Sub: MODIFICATION SHEET NO. RDSO/2024/EL/MS/0502, Rev. '0', Dated 07.10.2024.

MODIFICATION SHEET NO. RDSO/2024/EL/MS/0502, Rev. '0' , Dated 07.10.2024.**1. TITLE:**

Unloader valve control circuit modification in three Phase Electric Locomotives.

ANNEXURE- A

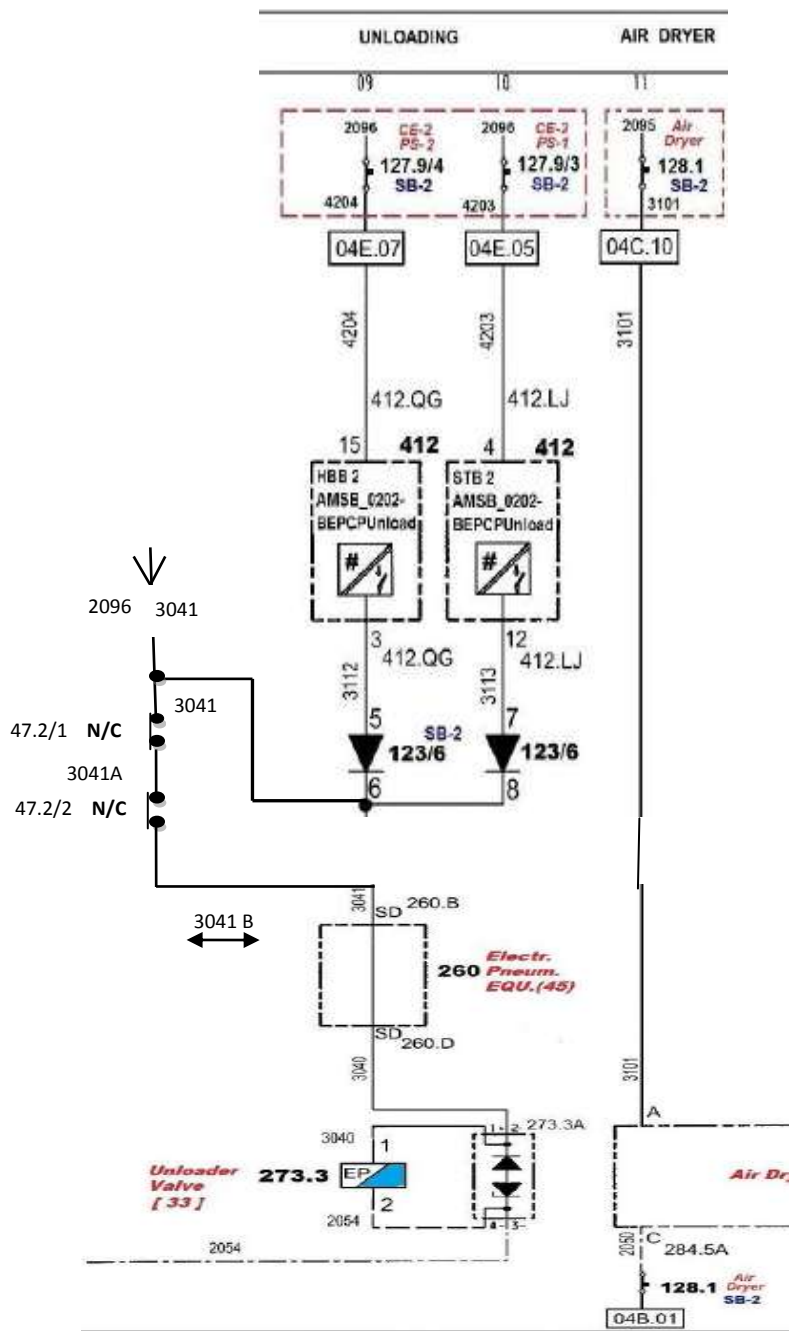
- i. The working period of ULV with command from VCU is 12 Seconds as per TC-113 and will work during CP cut-in duration and therefore MCP will start safely even when CV malfunctioning.
- ii. The command of ULV, ADV & oil separator is common and governed by VCU and synchronized with CPs start/stop command.
- iii. There are some cases of failure of ULV reported by Zonal Railways. Mostly, failures of ULV are attributed to poor maintenance, non-replacement of genuine spares timely or quality issues in the spare material. Overhauling periodicity of ULV& NRV has been revised from IOH to every IC schedule in terms of TC-142 Rev.1 issued vide letter no. EL/3.6.4/2 date 18-09-2023.
- iv. ULV & UL-MV are in scope of brake system. UL-MV is mounted on the brake panel, required less piping and wiring and being maintained along with components of brake system.

- i. Under this modification the VCU to DIO card 412 QG and 412 LJ output control supply through cable number 3041(SB-2 Panel) is parallel connected with wire no. 2096 (shown in diagram).The control supply to operate the CP unloader magnetic valve is being fed through CPs contractor's 47.2/1 & 47.2/2 NC aux interlock connected in series as shown in Annexure-B.

- ii. Due to this control of UL-MV is governed to CPs contactors pick up and drop, so when CPs are in service CPs contactors are in closed condition and CPs contactor's AUX interlocks are in N/O condition therefore the unloaders are in off state, and when CPs cuts off the N/O contact goes N/C and unloader valves goes in exhaust state when CPs are stopped.

- iii. This makes the CP starting off-load during cut-in and eliminating the possibility of CP MCB tripping online. It also eliminates spurious working of unloaders due to malfunction of control card of VCU.
